## Plot 23 Height:

### From “Equivariant Height, or Marginally Lower” to Approximately 3.64 Metres Higher

Before application **2026/91657** is determined, I ask the Council to require the applicant or developer to provide:

The first graph places Plot 23 and No. 92 within the wider sequence of existing dwellings and proposed plots along Lingards Road.

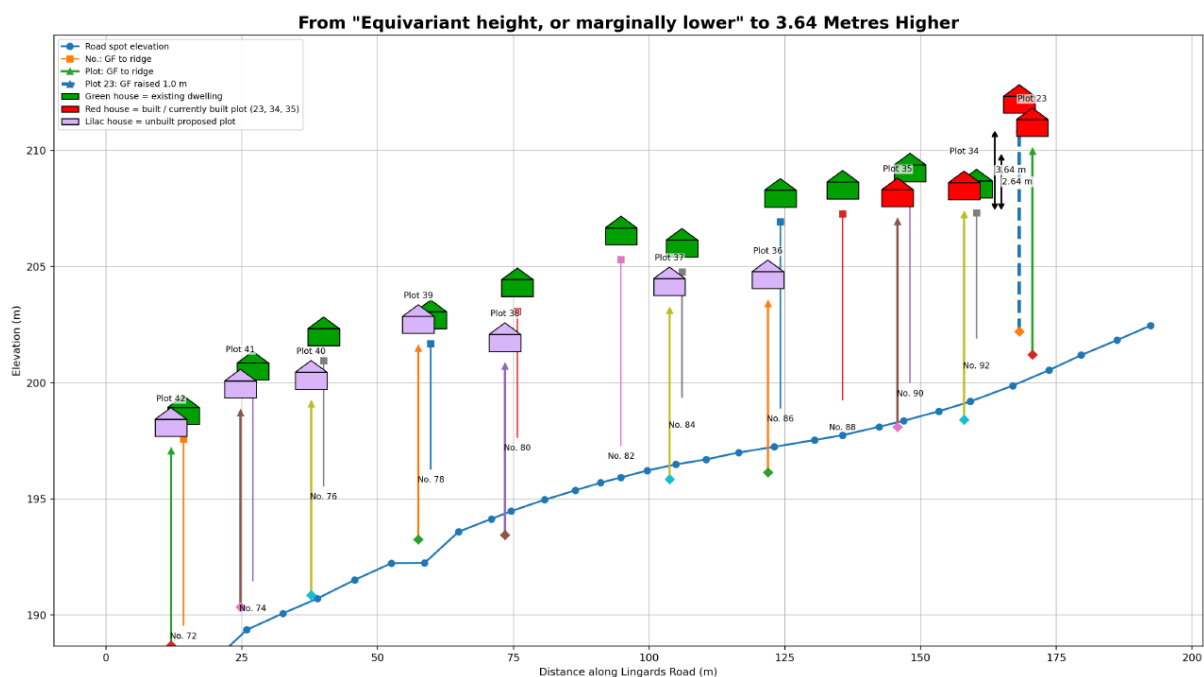
The comparative graph indicates that No. 92 is uniquely affected among the existing dwellings shown. It appears to be the only property where the directly related new dwelling rises substantially above the existing ridge. Plot 23 is approximately 2.64 metres higher on the submitted elevations and approximately 3.64 metres higher on the estimated as-built elevation. No comparable height relationship is shown elsewhere on the graph.

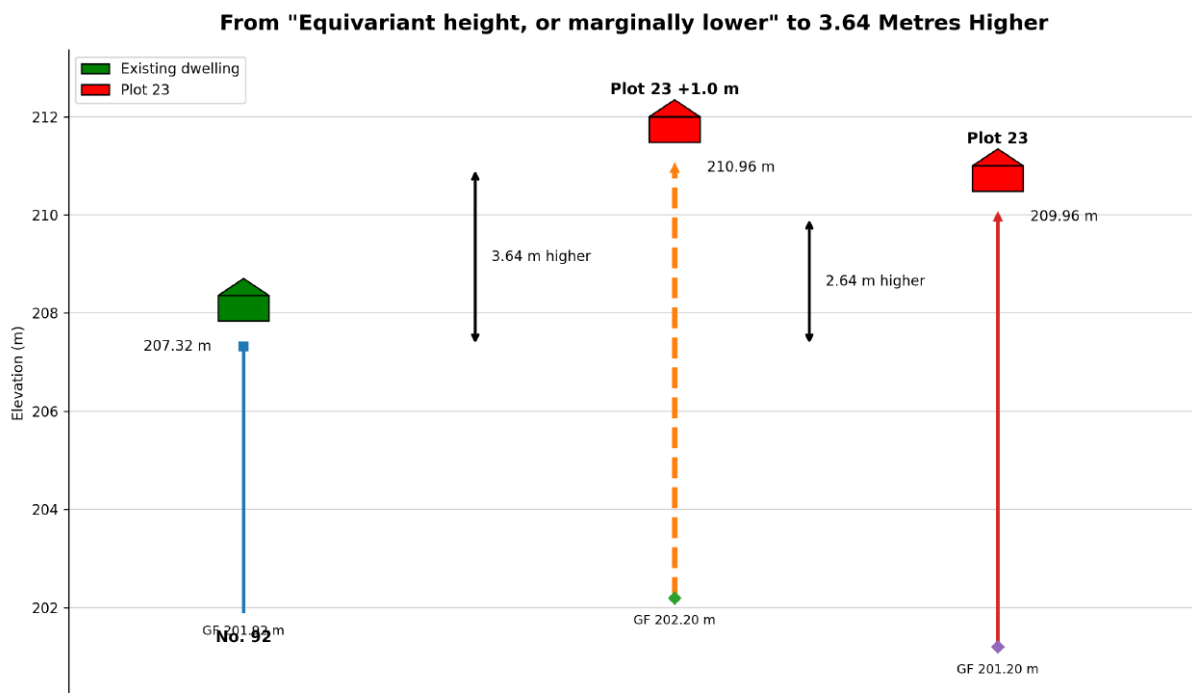
This is not an “equivariant” relationship, nor could a difference of this scale reasonably be described as Plot 23 being “marginally lower”. Plot 23 would instead be substantially higher than No. 92.
